**FOLLOW-UP ON THE NASSRIYA
PRISON FACILITY
NASSRIYA, IRAQ**

**SIGIR PA-08-131
APRIL 17, 2008**

COMMAND REPLY
to
**SIGIR Draft Project Assessment Report – Follow-up on the Nassriya Prison Facility,
Nassriya, Iraq**
SIGIR Report Number PA- 08-131
(Project PA-08-131)

Figure 4. Inmate housing design (Figure courtesy of the USACE)

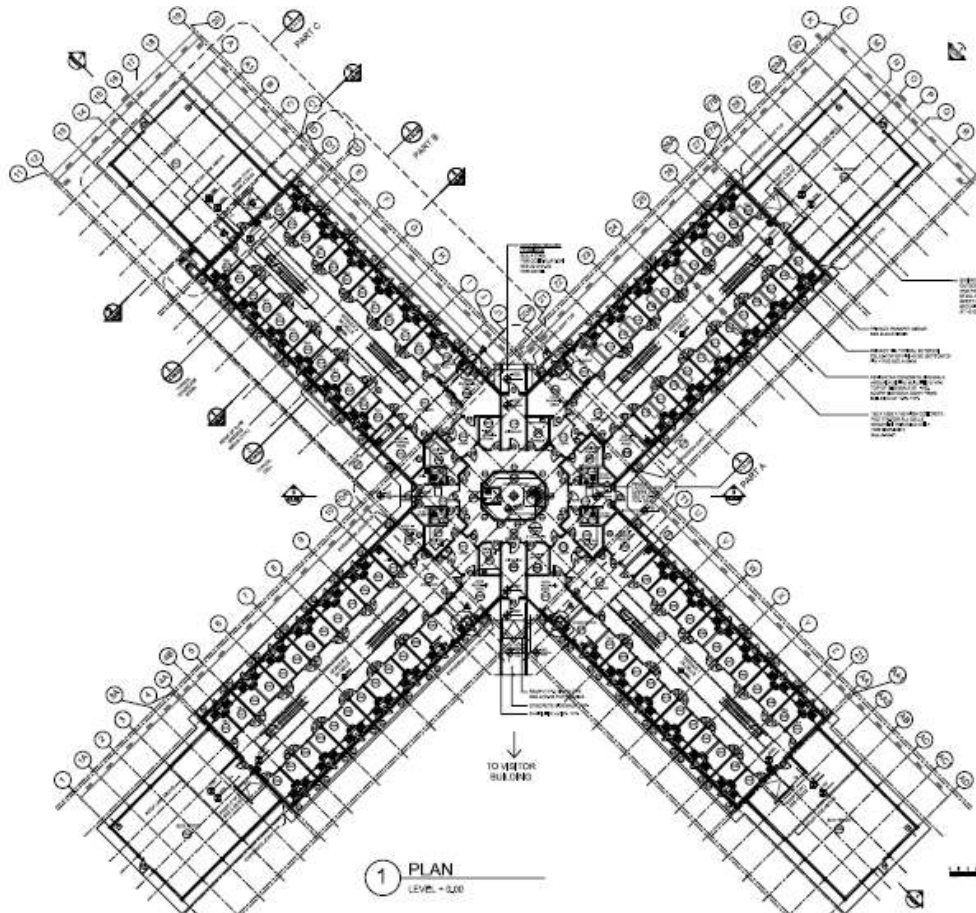
3. **Draft Report, Page 7 – last sentence and top of Page 8.** The four wings of each housing unit were designed to contain two floors of inmate cells with 24 cells per floor in each of the four wings for a total of 192 cells per building (Figure 4).

Command Comment. Change the sentence to read, ""The four wings of each housing unit were designed to contain two floors of inmate cells with 26 cells upstairs and 24 cells downstairs in each of the four wings for a total of 200 cells per building (Figure 4)."
